N6734B-01

S E R V I C E N O T E

N6734B 50W DC Power Module

Location of C36 and C37

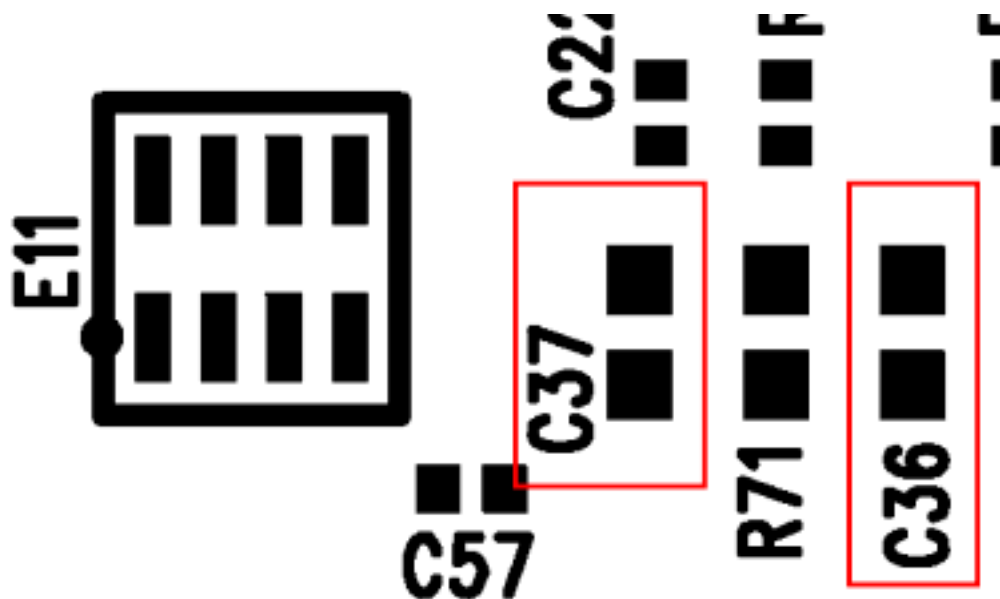
Due to some noise filtering issues, the current measurement accuracy will be out of specification by a fixed offset when there is a voltage being sourced at the output terminals. If the output is shorted, the current measurement accuracy will be within specifications. Please note that the performance verification test will not catch this.

If this measurement is out of specification, replace capacitors C36 and C37 on the DPM assembly (this is the assembly that is vertically mounted in the unit that looks similar to a PC memory module) with part number 0160-7809. After the capacitors are changed, the unit will require re-calibration. After the capacitors are replaced, check the make sure that the unit is in specification by applying 75% of the full voltage range while attached to a load drawing 50 mA to 70 mA. If the current measurement is within the specification, then the unit has been repaired.
